By Mike Josiah and the Technical Staff at UniNet

Instead of writing a specific cartridge instruction manual, we thought it would be a good time to go over some changes to cartridges that happened in 2013 and to also alert you to possible issues with a specific series of printers. We will cover the following: remanufacturing mistakes; OEM changes to cores and how this affects you; as well a note on a printer series that could have catastrophic effects on your customer's printer if you're not aware of the issue.

DELL 1130 CORE CHANGE

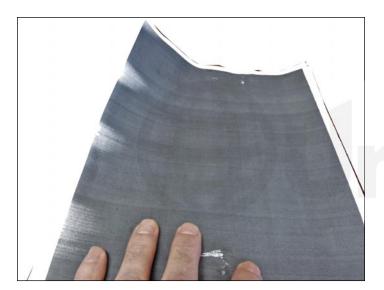
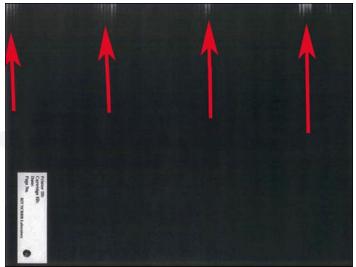
On the left picture you see the older black softer plastic bushing.

The right picture shows the newer (harder) white plastic bushing.

This change was made because the softer black bushings were wearing out in an oblong shape and allowing the drum to move. Depending on the wear, light to severe banding will be seen on the printed page.

The old style end cap pictures are shown here with black bushings.

If you look at the drum axle bearing hole you'll notice wear marks and that the hole is slightly elongated.

You can also see small strands of plastic hanging off the center of the bearing.

The new end caps have a new drum axle bearing made of a much harder (and what appears to be) self-lubricating plastic.

Take a look at the cores you have in stock. If you have the newer ones with the white plastic bearings, you should be fine, but if they have the older softer black bushings, inspect them carefully. If the hole is not perfectly round, your test prints will show banding.

No new replacement caps are currently available, but we are currently investigating a replacement bushing and/or end cap system.

SAMSUNG END CAPS (A GENERAL TIP ON ALMOST ALL CORES)

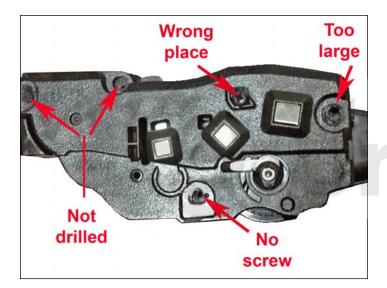
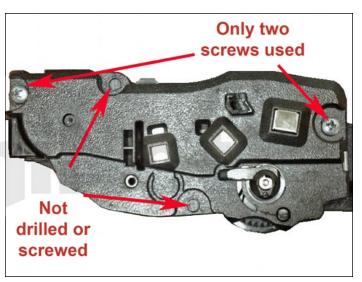
Two Examples of What Not To Do: A Dremel type tool was used to cut the rivets off and drill the holes for the screws (a flat chisel X-ACTO type knife works best). The holes for the screws are now too large and the screws will not hold the end caps on properly. We have found that using a #29 drill bit and a #8 x $\frac{1}{4}$ " self-tapping screw works best.

Shown are a few problems: posts were not drilled and screwed; only two screws were used instead of four; an extra screw was installed in the wrong place; and one of the holes (not screwed) is too large for a screw to hold that point in place properly.

SAMSUNG MLT-D205 CARTRIDGE

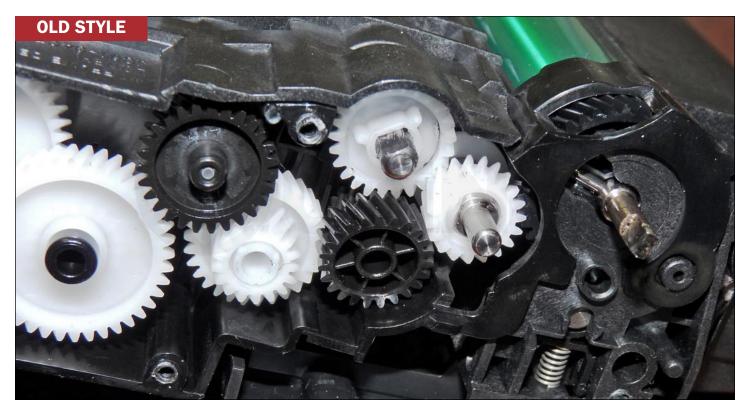
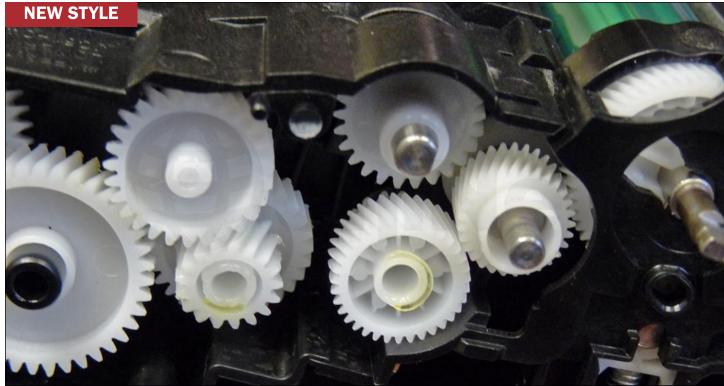
Samsung has made a change to the MLT-D205 cartridges. There is now a new style and an old style. The new style uses a new drive gear with more teeth. The old gear had 39 teeth, and the new one has 59 teeth. It is believed this change was made to enhance the grayscale capability of the cartridges (smoother grayscales).

Shown here are the full gear trains of both the **old** and **new** styles...

In addition to the new drive gear in the drum there are also two new internal cartridge gears.

The old drums will not work in the new cartridges, nor will the new drums work in the old cartridges.

UniNet has been working on this since the first cartridges appeared and now has a solution available: #18694 SuMMiT® drum with gears for use in Samsung ML 3310, 3312, 3710, 3712, 3750, SCX 4833, 5737 (MLT-D205) (59-tooth gear)

It is very easy to tell the old and new versions apart. Just look at the bottom of the cartridge. The fine tooth gear is the new style. The OEM old style has been black and to this point, the new OEM gear has been white, but there is no guarantee it will stay that way.

CHANGES TO SAMSUNG MLT-D104 CARTRIDGES

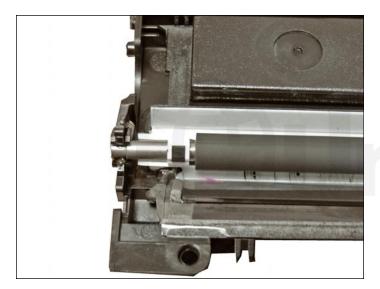
Samsung has made a change to the MLT-D104 cartridges. There are now shipping locks installed on the PCR shafts. These new locks run alongside the edges of the wiper blade as they fit through the cartridge. Because of this change a new wiper blade was needed.

You can easily tell the two versions apart by looking at the top of the cartridge. There are colored plastic shipping locks visible on both the right and left sides. The top cartridge pictured above is the new version.

UniNet is currently developing a new blade for these cartridges, and the instructions for this cartridge have been updated to show the differences between the two blades and the cartridges.

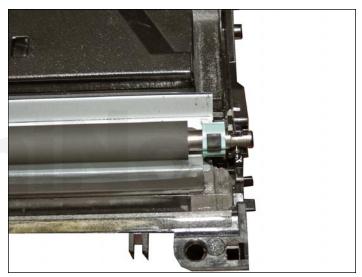
You can see the differences between the two blades.

The top blade is the new version.

Shown are the two versions of the cartridges from the inside. The new version is pictured on top.

As mentioned earlier, new blades for these cartridges are in development.
